DS-K1T342 Series MinMoe V3.16.1_build240701 Release Notes (2024-07-09)

DS-K1T342 Series MinMoe V3.16.1_build230802 Release Notes (2023-08-22)

DS-K1T342 Series MinMoe Terminal
# V 3.16.1_build230802 Release Notes (2023-08-08)

DS-K1T342 Series MinMoe Terminal
Release Notes (2022-03-09)

16. **Network**

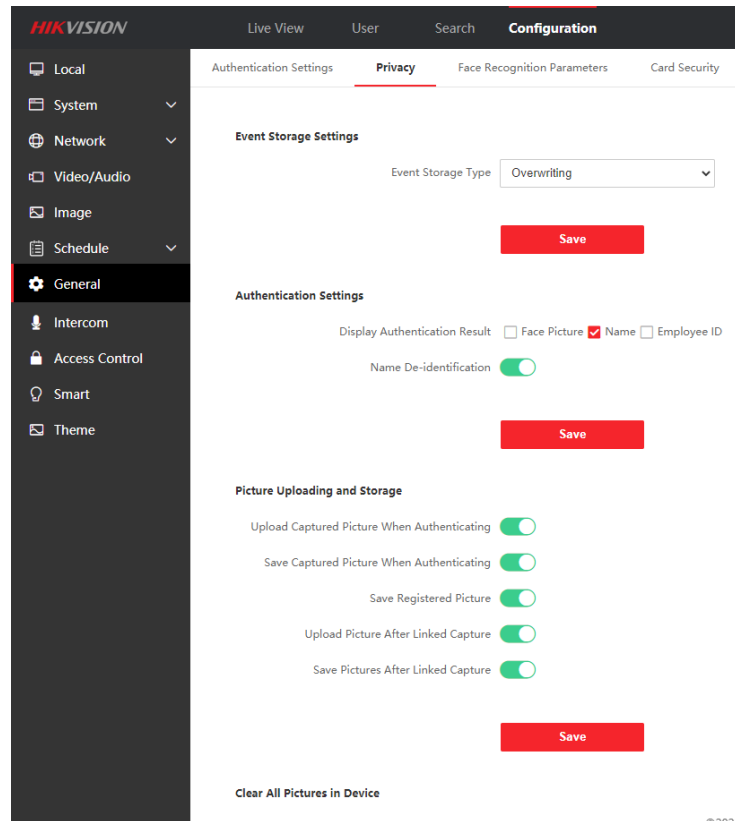
Support TCP/IP and Wi-Fi (model with W only), adapt to LAN(network) or WAN(ISUP 5.0) network environment.
